HISTORIC CONSERVATION BOARD

Monday, March 24, 2025 at 3:00 pm

APPLICATION FOR CERTIFICATE OF APPROPRIATENESS HISTORIC CONSERVATION BOARD PUBLIC HEARING STAFF REPORT

APPLICATION #: COA2025004
APPLICANT: AJ Backscheider
OWNER: Notoro Management, LLC
ADDRESS: **341 Milton Street**
PARCELS: 086-0002-0261
ZONING: RM-1.2-T
OVERLAYS: Prospect Hill Historic District
COMMUNITY: Mt. Auburn
REPORT DATE: March 10, 2025
STAFF REVIEW: Douglas Owen, Urban Conservator

Figure 2. Image of subject property facing northeast ca. November 2024. Image from Google.

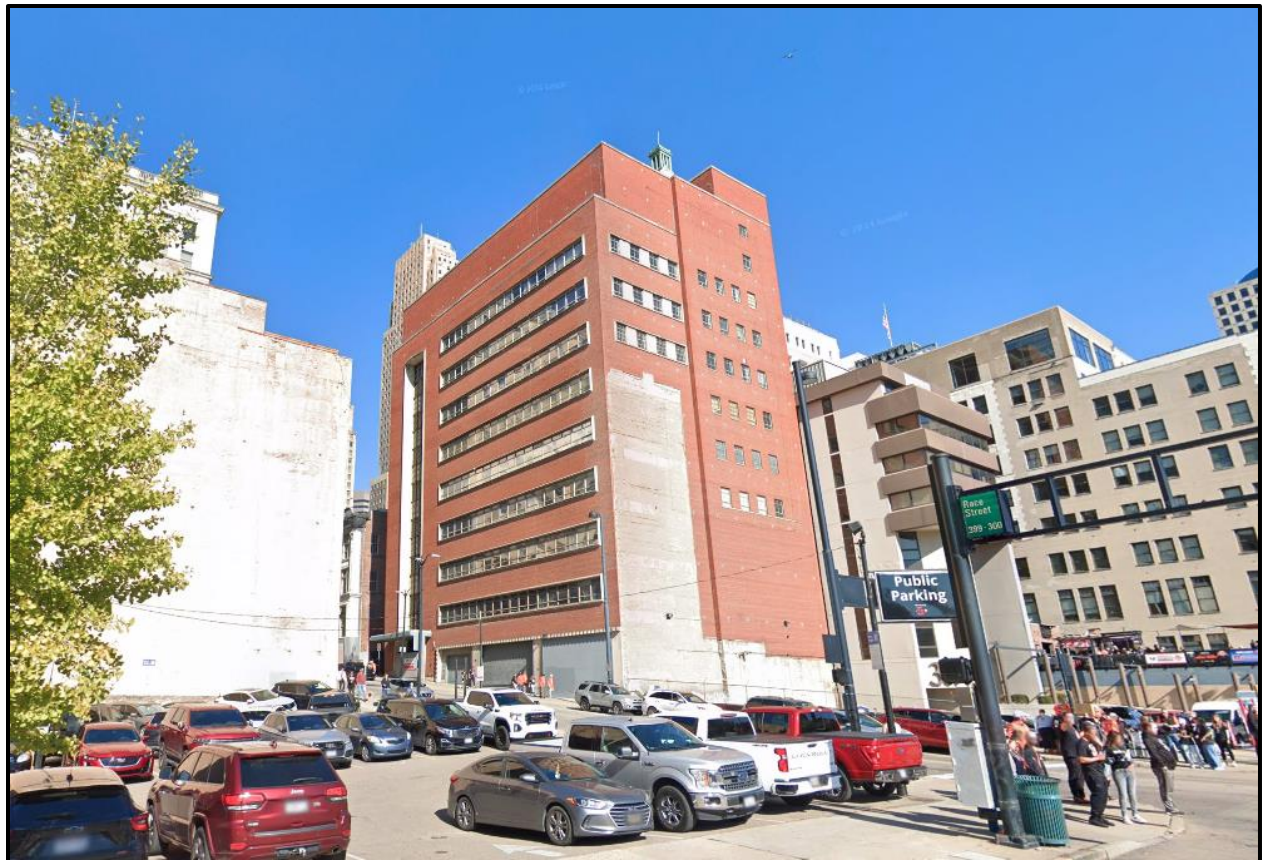
New materials are primarily limited to the window replacement and the upper penthouse addition. Existing steel windows are badly deteriorated and in need of replacement as indicated by the window survey provided by the applicant. The proposed aluminum window replacements are discussed in further detail below. Existing brick is in good condition and will remain with minor tuckpointing where required. Limestone detailing will be retained. Where damaged, limestone patching with a stone patching material (such as Jahn M70 Limestone Repair Mortar or equivalent) will be used. This is an appropriate treatment for damaged limestone.

Existing exterior doors throughout the building are non-original replacements. The canopy over the Race Street entry may be original but has been re-clad with modern sheet metal. The Race Street entry is a later aluminum replacement storefront door. The applicant plans to replace the entry system, recessing it from the front of the building by approximately 5' to provide for an ADA compliant entry. The sloping sidewalk adjacent to the entry requires a ramp and landing for adequate wheelchair turning radii and door swings, necessitating the recessed

The canopy over the Race Street entry will be retained and the non-historic sheet metal removed. Once the later material is removed, the condition of the historic structure will be assessed and the canopy will be repaired and reclad with a similar material. The canopy cladding may be approved by Staff after the exploratory demolition is complete and a repair plan is identified.

A new vehicular entry is proposed for the south elevation, allowing access to the basement parking garage. The opening will consist of a 15' wide coiling steel gate entry with horizontal slats placed within the parged concrete facing. A section of the wall to the east of the gate will be parged and these two sections will be framed with a simple cast stone surround inspired by the detailing of the original building. The additional parged area will help to provide symmetry on the south elevation, framing the four window opening columns above, as the new vehicular entry is required to be off-center due to the building structural elements and parking access area location. A new pedestrian door will also be installed at the rear corner. This elevation is more utilitarian in nature, especially on the lower levels where ghosting from a previous building exists. The utilitarian coiling gate will not detract from the character of the building in this location.
